CITY OF KIRKLAND
Planning & Community Development Department
123 Fifth Avenue, Kirkland, WA 98033
425.587.3225 - www.kirklandwa.gov

ADVISORY REPORT
FINDINGS, CONCLUSIONS, AND RECOMMENDATIONS

File: SAR14-00665, Gong Reasonable Use Permit

C1 SITE PLAN
SCALE: 1"=20'-0"

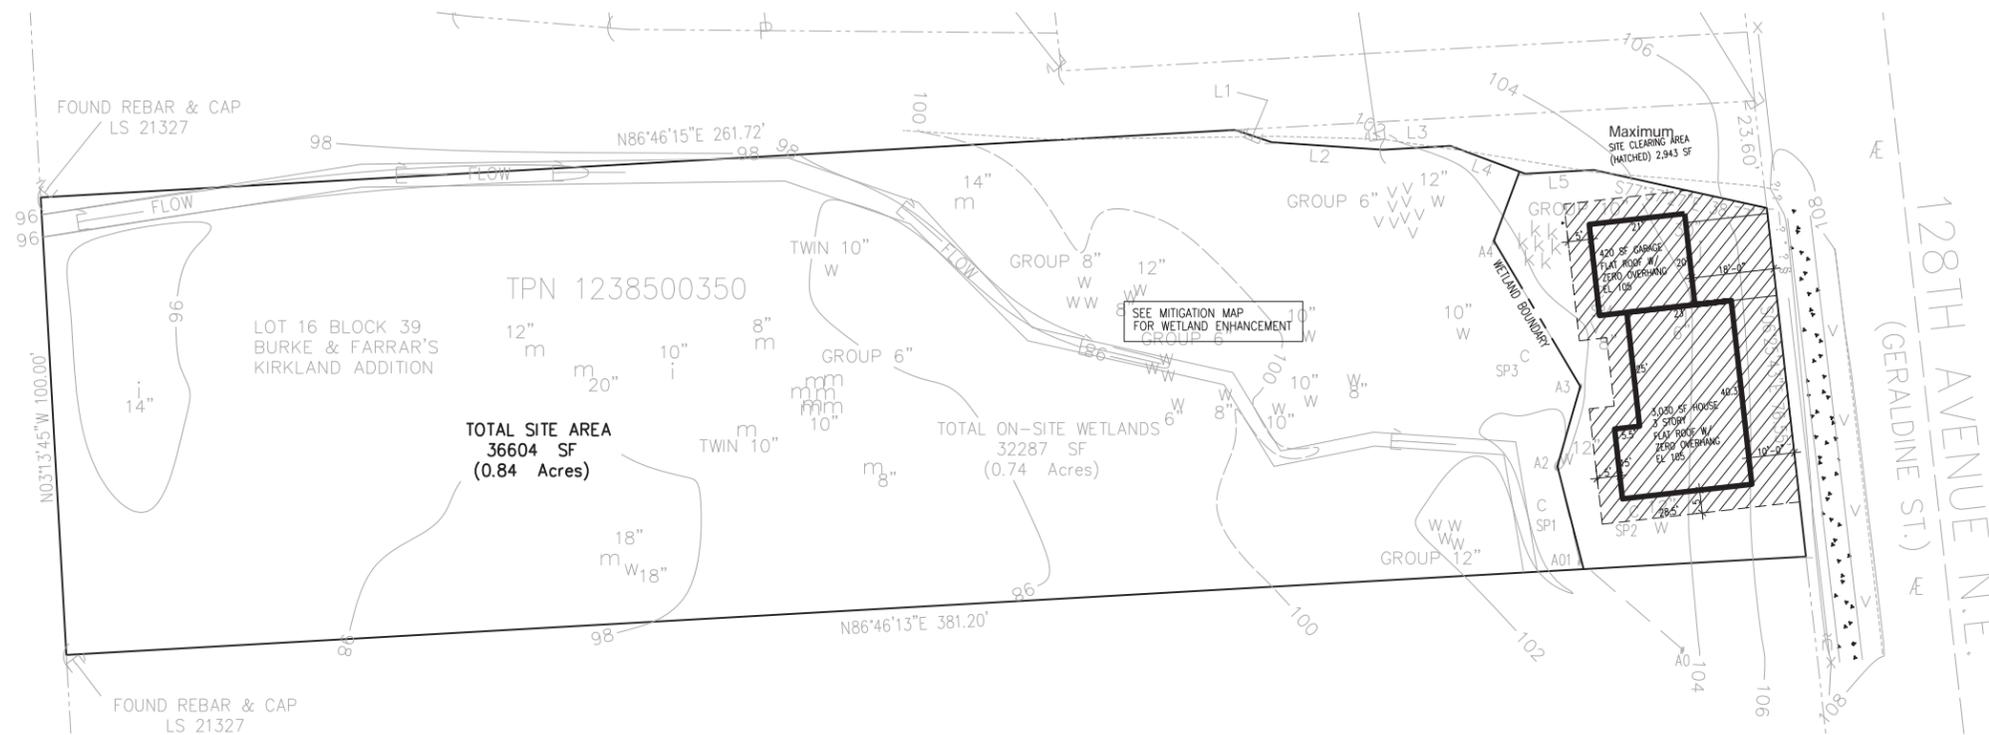
2. The proposed modification to reduce the required front yard setback by 10 feet, as allowed by KZC Section 90.140.7, is approved. Any changes to the approved site plan must be reviewed and approved by the Planning Department (see Conclusion II.C.11).

- (3) KZC 15.30 requires a minimum 20- foot wide front setback yard in the RSX zone (see Attachment 7). The applicant requests a modification to this requirement and proposes a 10- foot wide front yard setback along the east property line for the living portion of the home and an 18 foot-wide front yard setback for the attached garage. The proposed modifications are discussed further in Section II.E.11 below.

- (2) The proposed reductions to the required front yard as shown on the proposed drawings will minimize potential impact to the sensitive areas and their buffers (also see Section II.C.11 for modification criteria for required yards on reasonable use sites).

- (7) In order to comply with Kirkland Zoning Code section 90.50, the applicant should submit as part of a building permit, a revision to the site plan (see Attachment 2) to exhibit a split rail fence with signage around the property at the site disturbance boundary as shown in Attachment 2.
5. Decisional Criterion 90.140.5.d: The proposal is compatible in design, scale and use with other legally established development in the immediate vicinity of the subject property in the same zone and with similar constraints.

- (3) The proposed modification to allow the house to encroach in to the front yard setback by 10 feet should be approved. Any changes to the site plan should be reviewed and approved by the Planning Department.

FLOOR PLANS AND SECTION

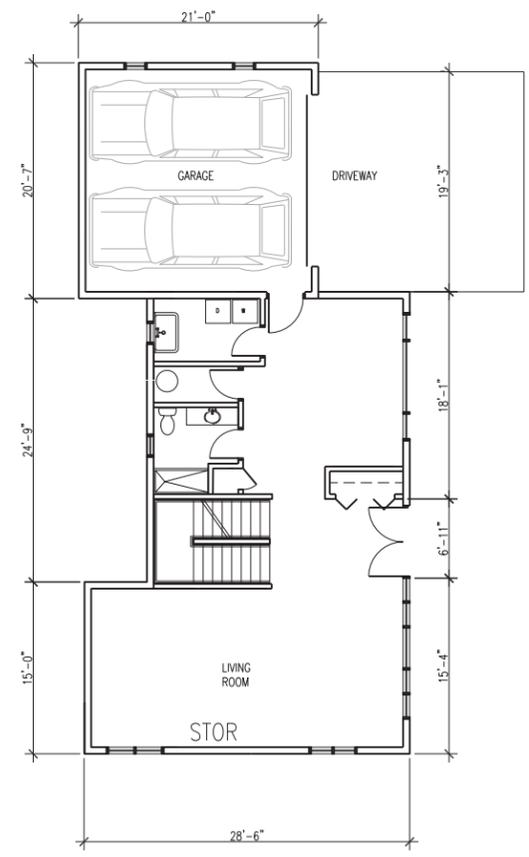
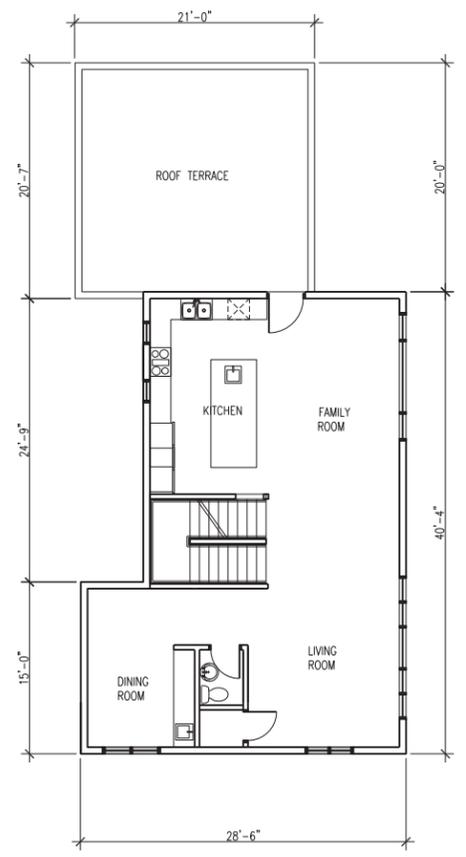
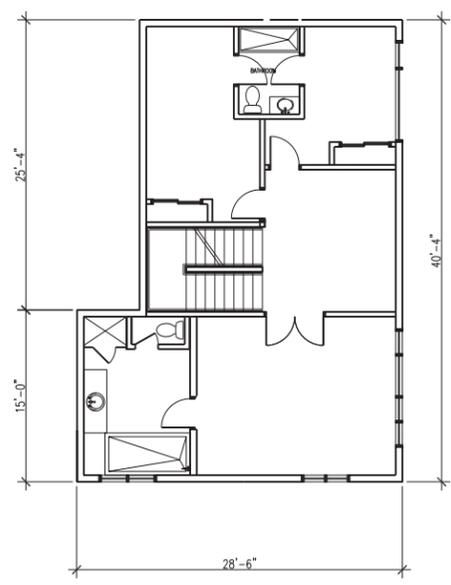
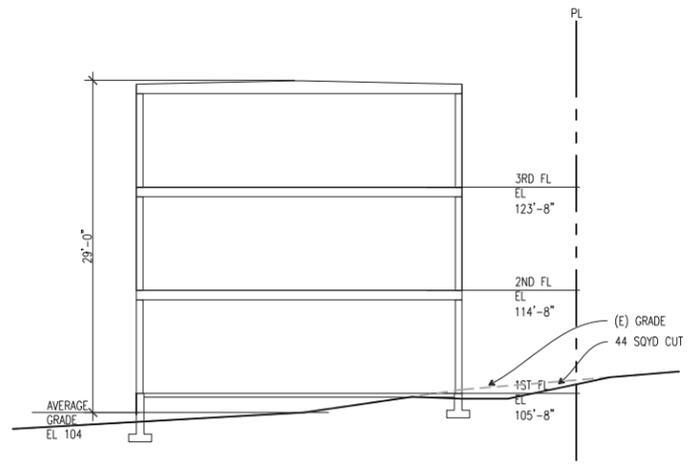
The public comment period ran from February 11th to March 6, 2015. Seven public comments were received (see attachment 4). Several public comments discuss the concern that the size of the house and garage were too large and will not fit in with the neighborhood. It was also expressed that the average setback from the east property line adjacent to 128th Avenue NE for other properties is approximately 40 feet, whereas the applicant's plan shows a 20 foot setback for the garage and a 10 foot setback for the home. A few comments reflect the loss of vegetation, habitat and the specifically the maple trees on the northeast corner of the property.

Staff Response: The applicant initially proposed a three story structure, with a total floor area of 4,050 square feet. Staff discussed the concerns about the size of the home with the applicant and the home was reduced in size to 3,450 square feet which was achieved by eliminating a second and third story above garage (see revised floor plan in Attachment 2).

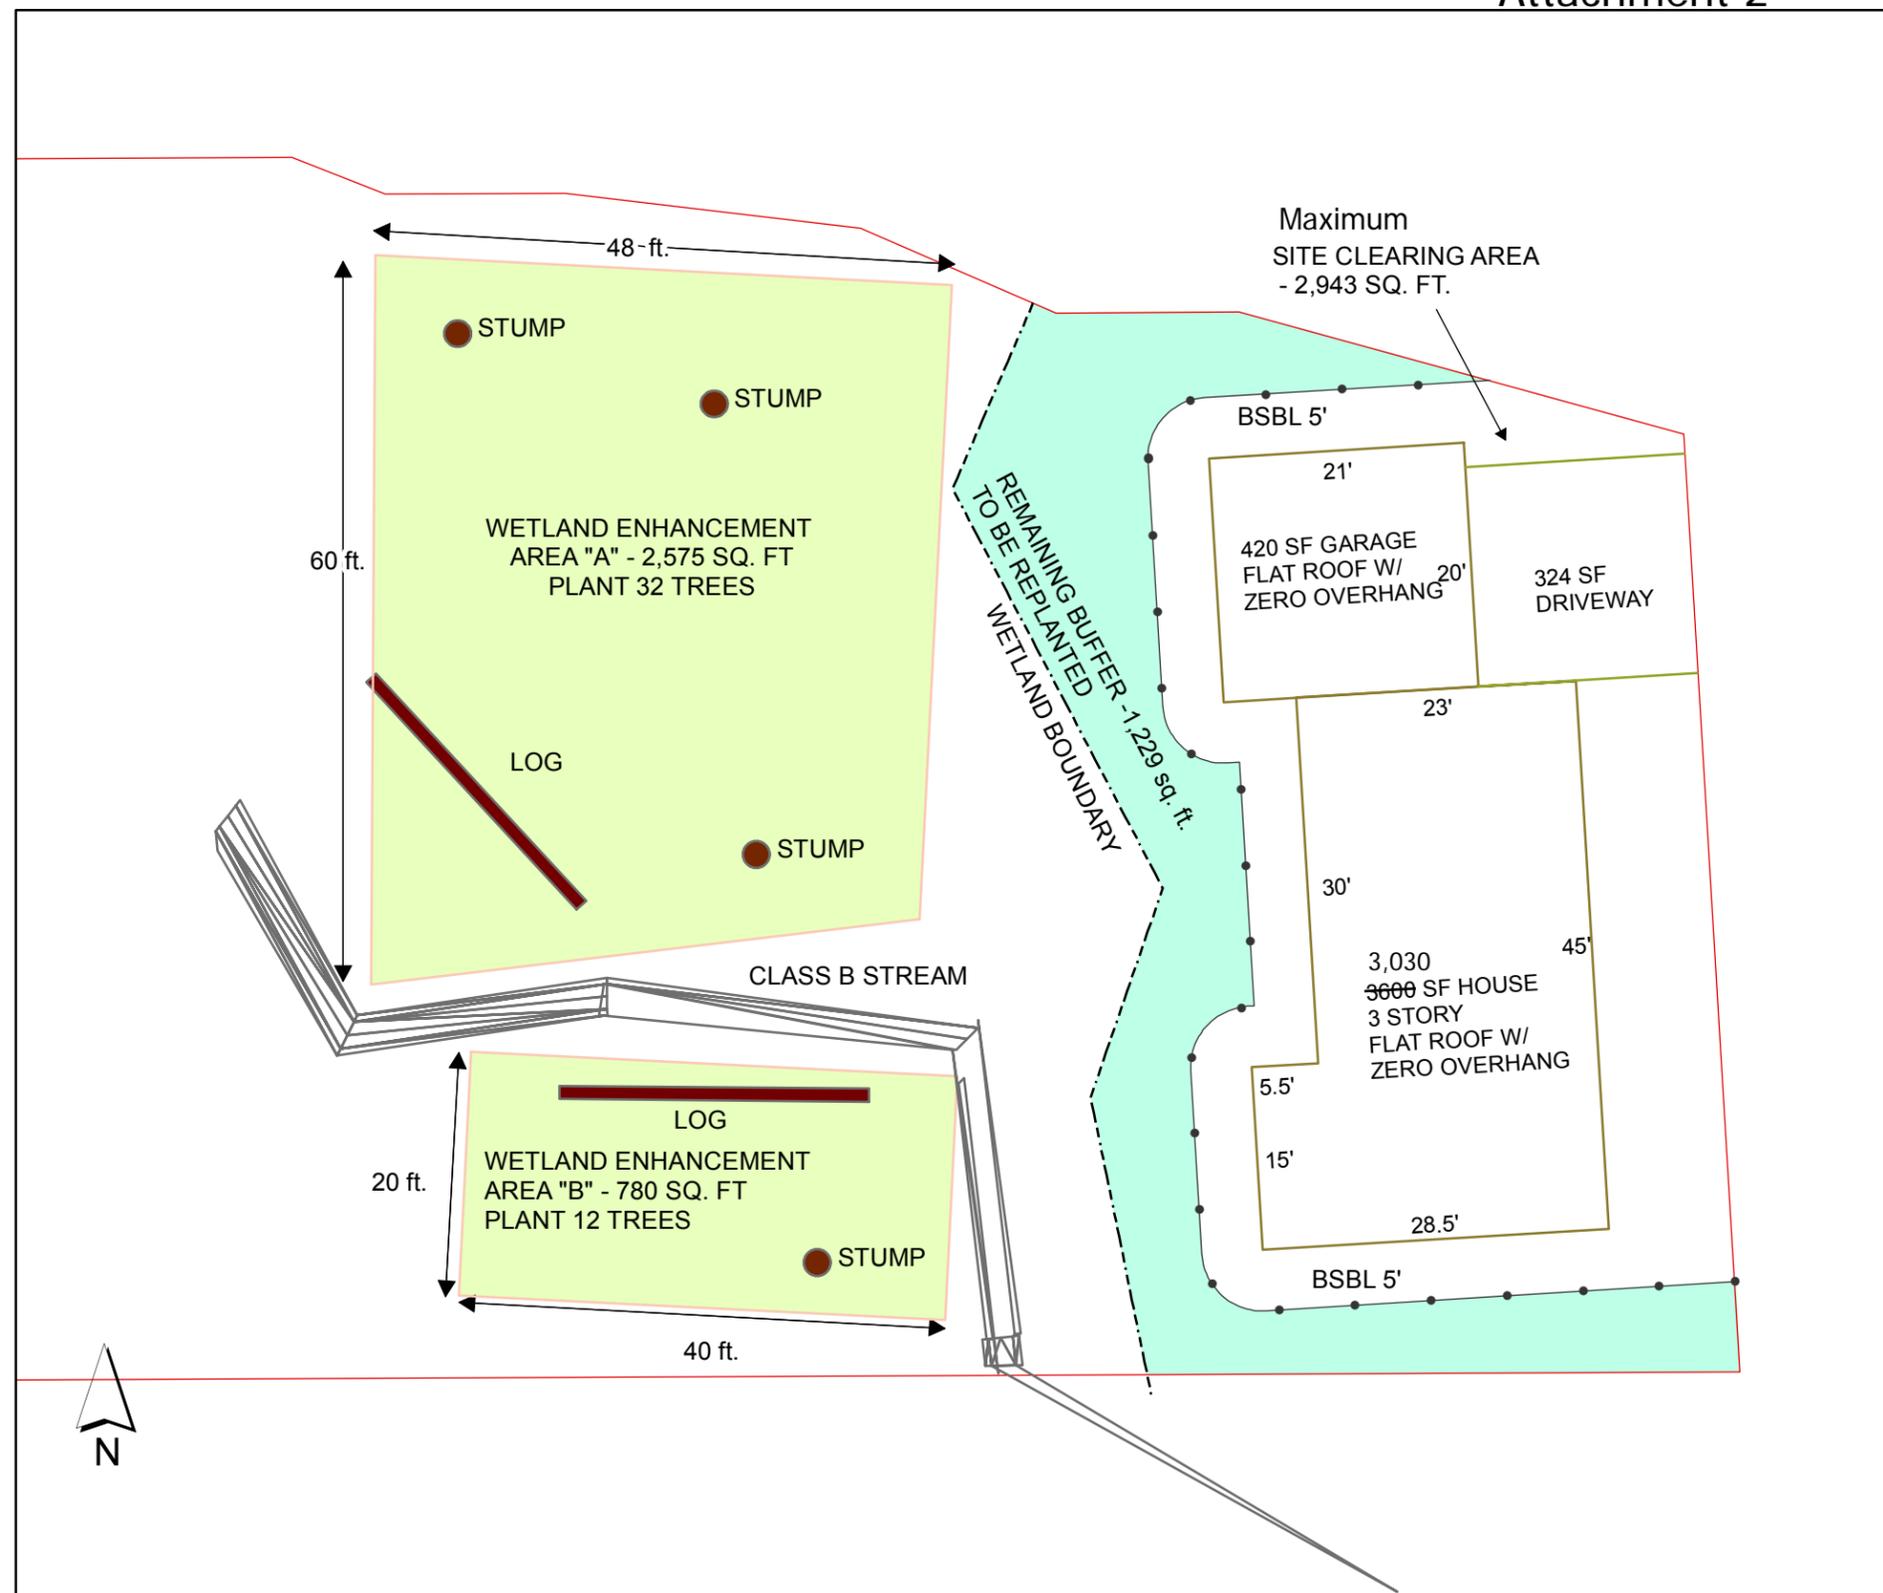
- (5) The wetland and stream buffers have both native and invasive species present. The Watershed Company has indicated 7 recommendations for changing the mitigation plan to insure that the plan will meet requirements of the Kirkland Zoning Code for reasonable use applications (see Attachment 6, Watershed report dated February 5, 2015). All of the Watershed Company's recommendations have been incorporated into the applicant's mitigation plan.

- (3) The applicant submitted a final wetland mitigation plan (see Attachments 2) that was reviewed by the Planning Official for compliance with the Watershed Company's review letter dated February 5, 2015 (see Section II.C.4).

- b. Conclusions:
 - (1) The proposed wetland mitigation plan meets the minimum standards of Chapter 90 KZC for mitigation, maintenance and monitoring as it includes the additional requirements from the Watershed Company's report dated February 5, 2015.

- (2) As part of the building permit application, the applicant should submit:
 - (a) Development plans that incorporate the approved wetland buffer enhancement, monitoring, and maintenance plans. Prior to submission of the permit, the applicant shall pay

- for an additional review by the City's consultant to ensure that the recommendations of the consultant have been followed.
- (b) Erosion control plans, which should depict the location of a six foot high construction phase fence along the boundary of the entire wetland buffer with silt screen fabric installed per City standard. The fencing should be installed prior to issuance of any permits. The fence should remain upright in the approved location for the duration of development activities.
